August 5, 2024

SUBJECT: Response to *GETS Progress Report #3 (Nov. 13, 2023 – May 12, 2024)*  
JCI/Tyco FTC PFAS, 2700 Industrial Parkway South, Marinette, WI  
BRRTS #02-38-580694

In this letter, the DNR provides a review of the groundwater extraction and treatment system (GETS) relative to the performance criteria JCI/Tyco set for this interim remedial action and requests that JCI/Tyco respond to questions the DNR has on JCI/Tyco's proposed updates to the GETS.

### Table 4 from GETS LTMP with checklist comparing to the content of GETS Progress Report #3

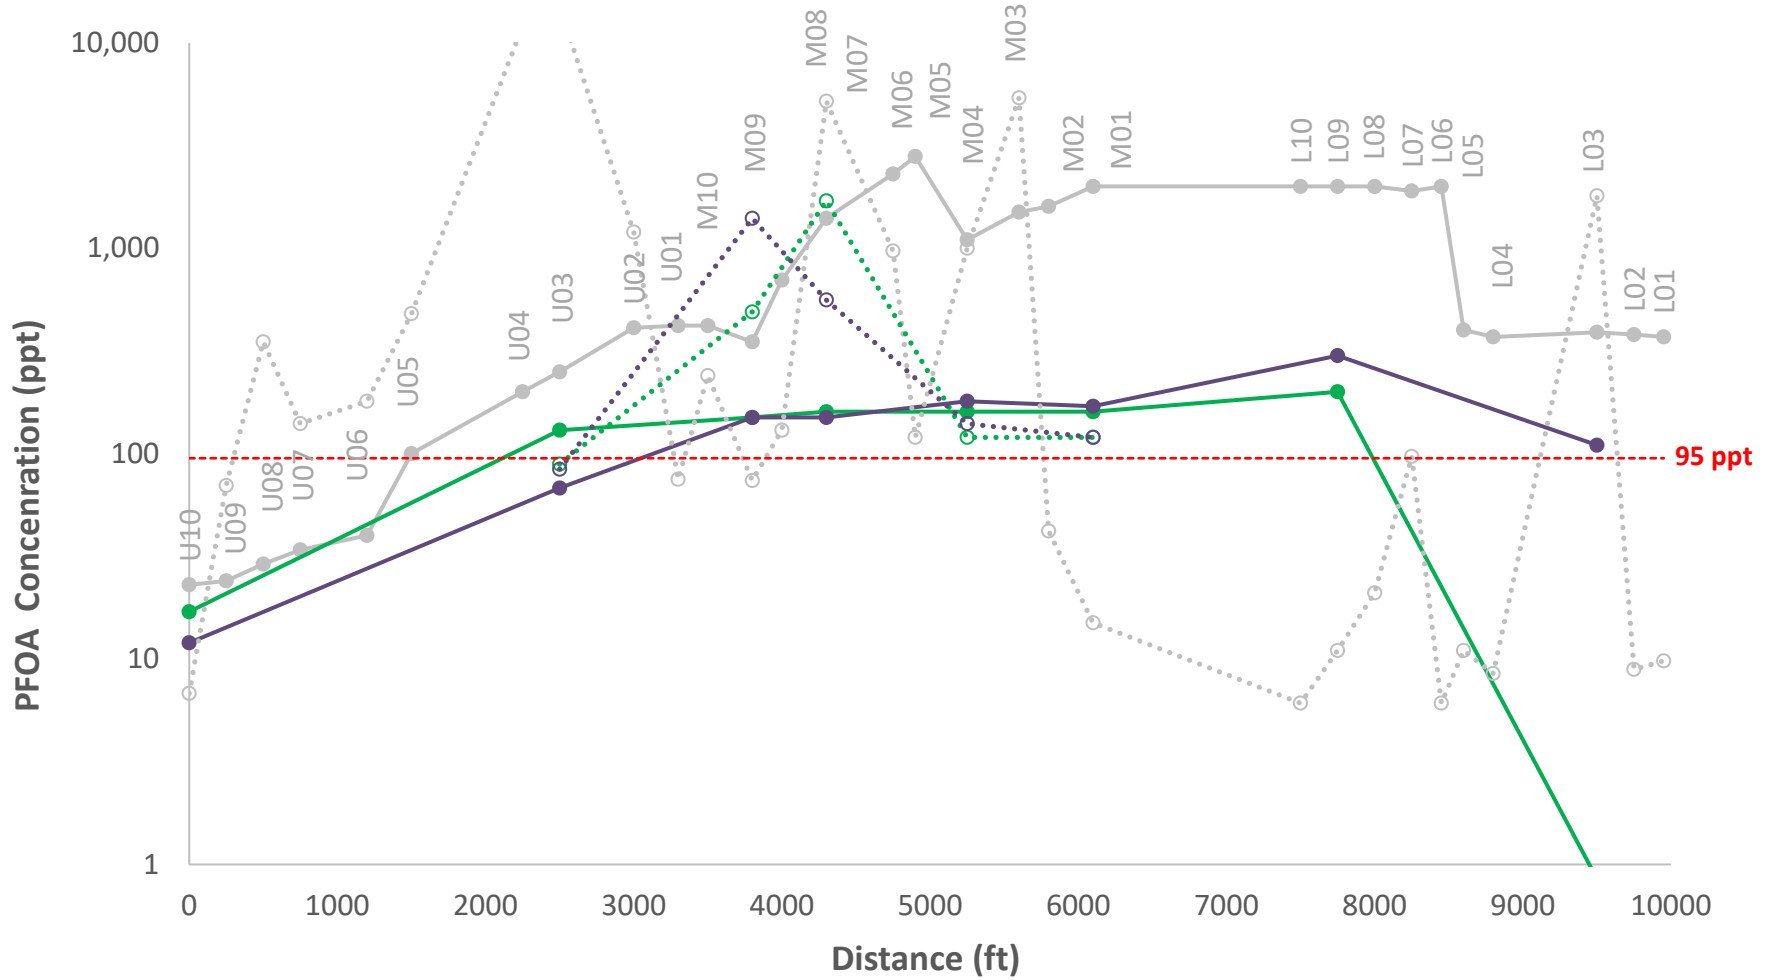
Performance Parameter	Evaluation Process	DNR's Comparison to June 2024 Report
<b>Document reductions of upwelling in upper, middle, and lower reaches of Ditch B and/or identify locations or conditions contributing to observed upwelling</b>	Calculate and track (in a table) head differentials in mini-piezometers and surface water	✓
	Calculate and track (in a table) the average system effluent rate and stream flow rate (at the existing Ditch B system) on days that mini-piezometers and surface water are gauged	✓
	Calculate and track (in a table) daily average flow rate in Ditch B and daily average effluent discharge rate and stream gauge measurements (when available)	✓
<b>Monitor and assess groundwater migration from the FTC (as it relates to the GETS and Ditch B specifically)</b>	Create tables and graphical plots (as needed) to summarize groundwater and surface water levels within the area of the GETS	✓

Create figures illustrating groundwater elevations and approximate capture zones of the extraction wells	✓
	Create cross-sections through the monitoring area (including Ditch B) illustrating wells, groundwater elevations, and approximate capture zones of the extraction wells	✓
<b>Document PFAS reductions in Ditch B surface water and/or identify locations or conditions contributing to potential increases</b>	Create tables summarizing PFAS concentrations detected in groundwater and surface water PFAS concentrations at mini-piezometers.	✓
	Create post-maps and trend plots illustrating PFOA and PFOS concentrations in groundwater and surface water at mini-piezometers overtime.	Add
	Create graphical trend plots showing contemporaneous flow rates and PFOA and PFOS concentrations for both GETS effluent and Ditch B surface water.	Add stream flowrate
<b>Document PFAS trends in groundwater (decreasing, stable, increasing) within the area of the GETS</b>	Create tables to summarize groundwater PFAS concentrations at monitoring wells over time	✓

Create graphical plots (as needed) to track concentration trends of specific PFAS constituents (e.g., PFOA, PFOS, PFHxA, and FTSA) at monitoring wells	Add (subset of wells)
	Create figures (e.g., isoconcentrations and cross-sections) illustrating concentrations of specific PFAS constituents (e.g., PFOA) in groundwater within the area of the GETS	Add (e.g. PFOA +PFOS isoconcentration on Fig. 10 and 11)
<b>Document PFAS mass removal over time</b>	Create a tabular summary of the average operating flow rate, run time, and volume of groundwater removed per month in each extraction well	✓
	Calculate and track (in tables and graphical plots) estimates of PFAS mass extracted from each well for the reporting period, and include updated cumulative estimated mass of PFAS extracted from each well since startup	✓
	Create a tabular summary of the total volume of groundwater extracted and treated per reporting period and cumulatively since GETS startup	✓

Create a tabular summary of the influent and effluent concentrations of PFAS from the GETS during the reporting period	✓
	Calculate and track (in tables and graphical plots) estimates of PFAS mass removed by the GETS for the reporting period, and include updated cumulative estimated mass of PFAS removed since startup	✓
<b>Evaluate sustainability of the GETS operation in accordance with NR 722.09(2m)</b>	Create a tabular summary of run time and down time of the GETS during the reporting period	✓
	Estimate energy usage by the GETS per reporting period and cumulatively	✓
	Summarize the carbon regeneration volume/mass per reporting period and cumulatively	✓
	Summarize the disposal volume/mass for filters and ion exchange resin per reporting period and cumulatively	✓

“Add” = content not found in the GETS Progress Report #3. Add as requested or when needed to document trends.

## Ditch B PFAS Mini-Piezometer Concentrations

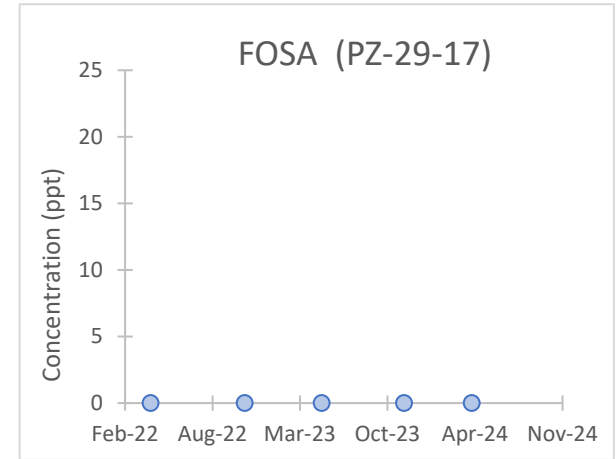
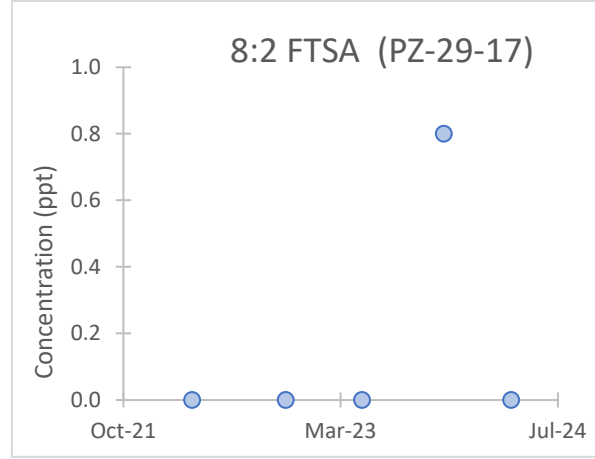
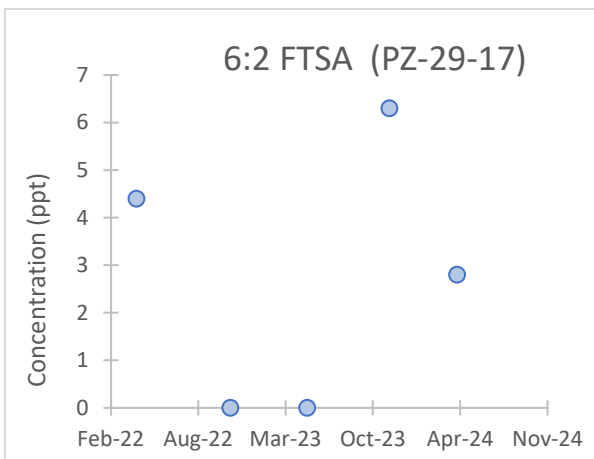
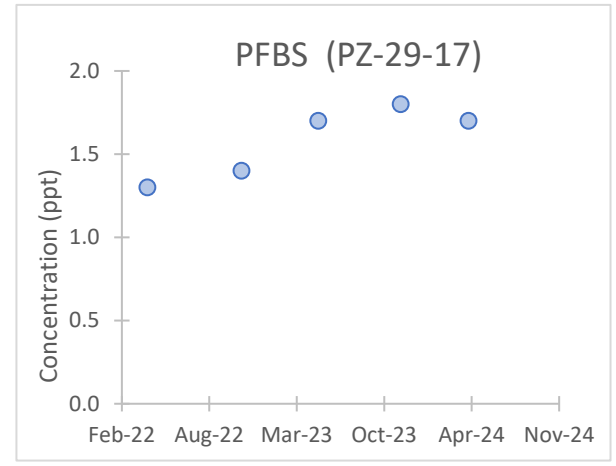
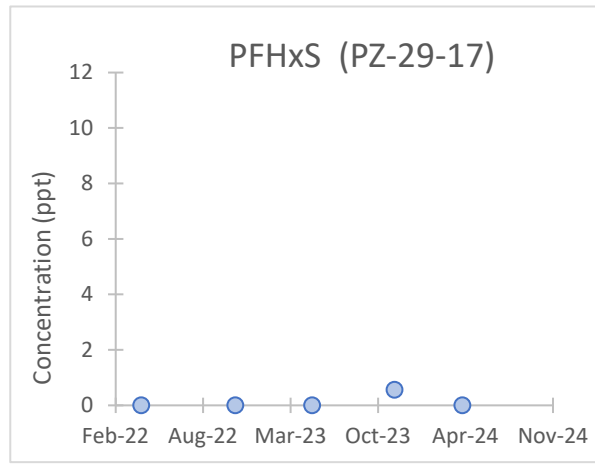
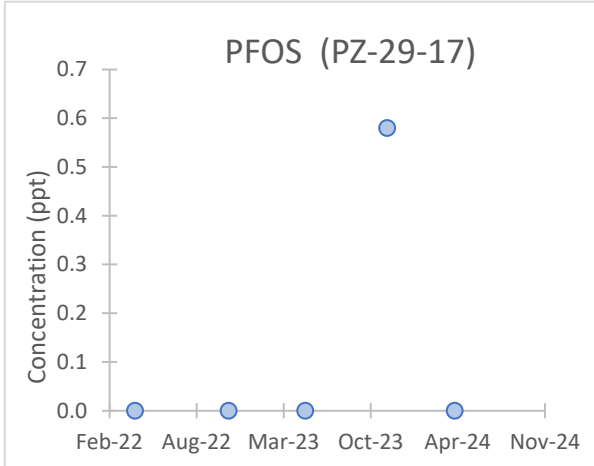
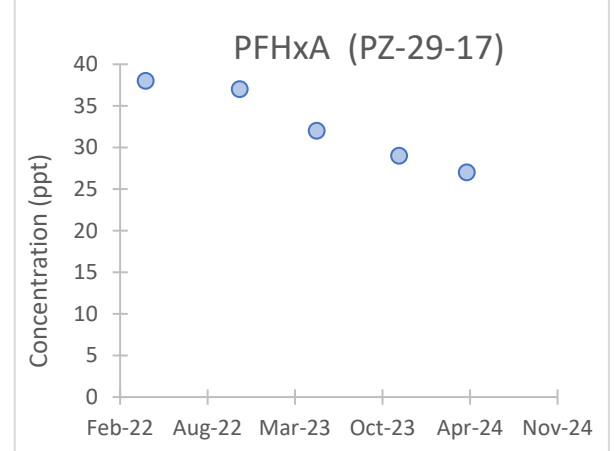
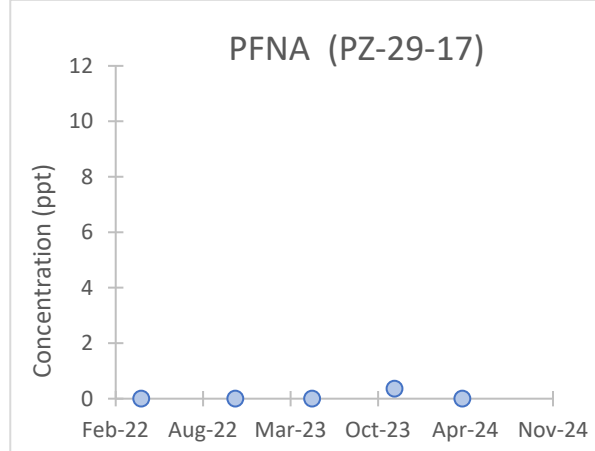
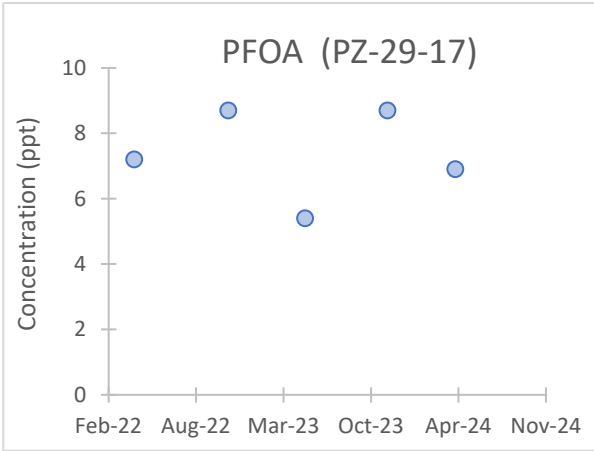
One likely contribution to these exceedances is the upwelling of contaminated groundwater that persists, albeit reduced, between monitoring points U10 through M07 as discussed above in item 1 and as shown on the first figure in Attachment B. JCI/Tyco's supplemental monitoring of surface water during this reporting period for points along the tributary to Ditch B near Pierce Avenue revealed that groundwater upwelling introduces PFAS contamination to this surface water tributary that enters Ditch B upstream of extraction well EX-3, near monitoring point M09.

As noted in Attachment A, JCI/Tyco should prepare trend plots to evaluate the cause of the elevated PFAS concentrations detected in Ditch B. These plots include, spatial plots of PFAS concentrations from the streambed mini-piezometers (see example in Attachment B) and temporal plots that overlay streamflow rate with PFAS concentrations at selected locations.

## Groundwater PFAS Concentrations

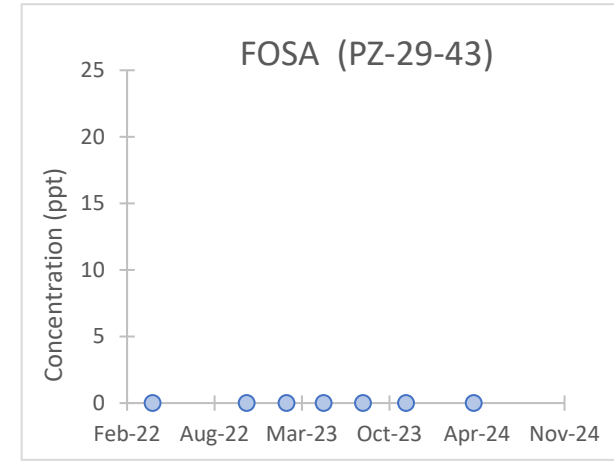
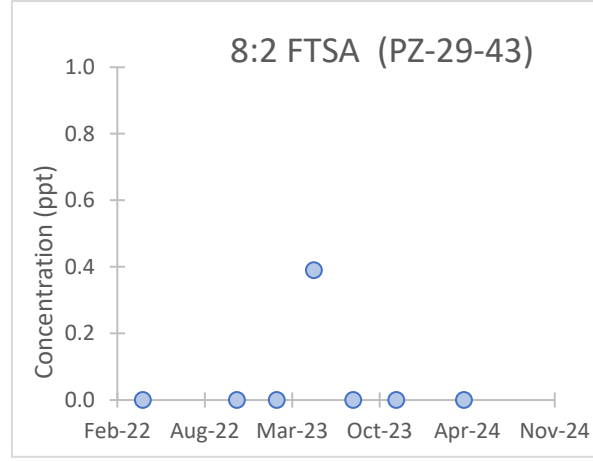
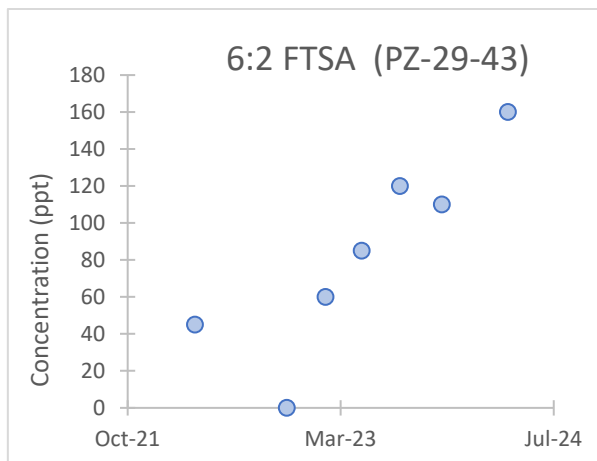
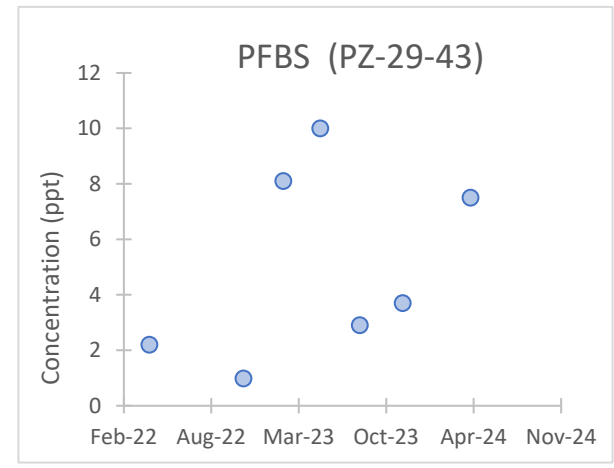
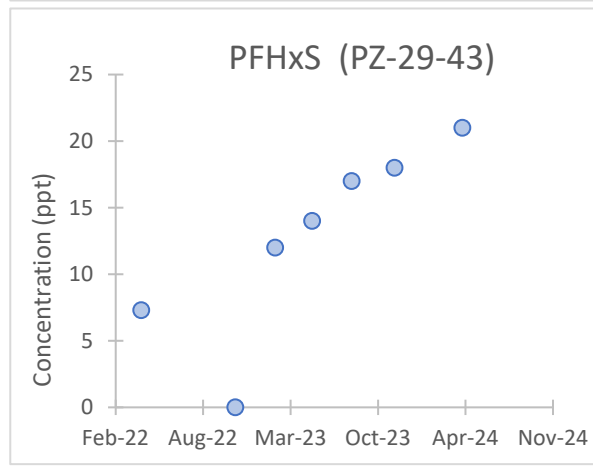
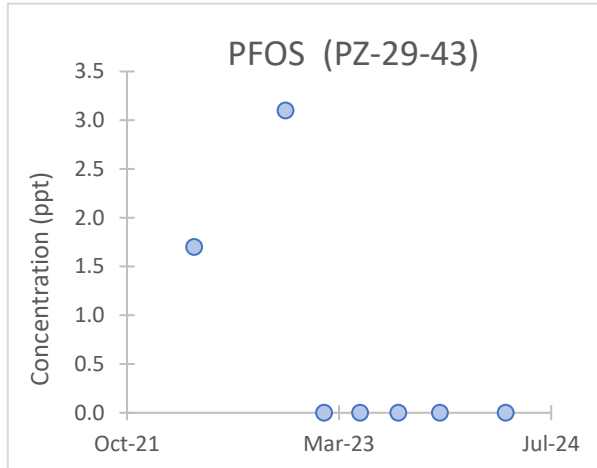
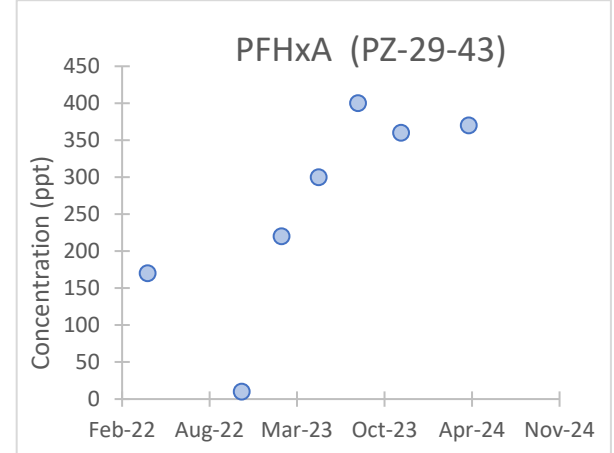
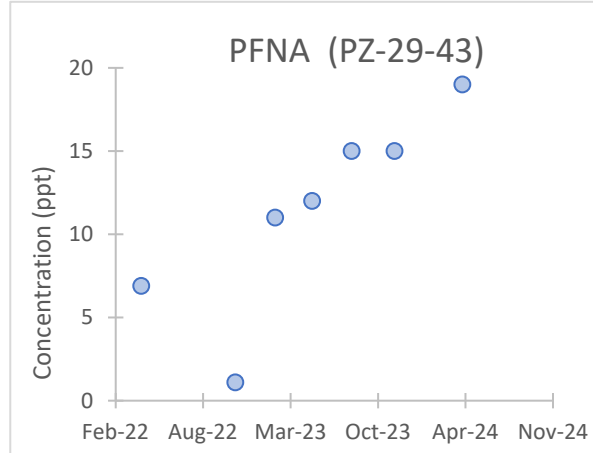
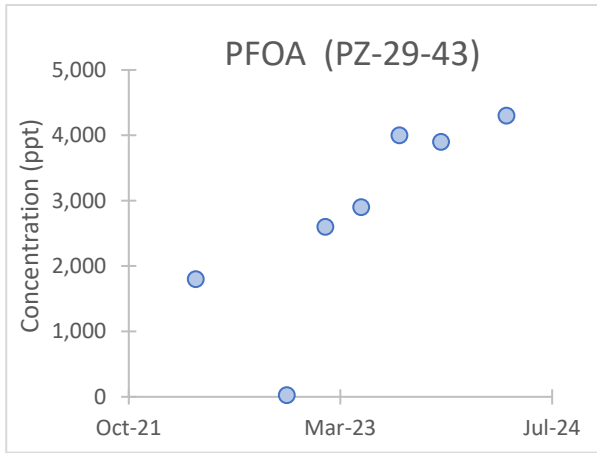
As noted in Attachment A, the DNR recommends that JCI/Tyco add trend plots for certain PFAS in selected wells within the area of influence of the GETS (see example in Attachment B).
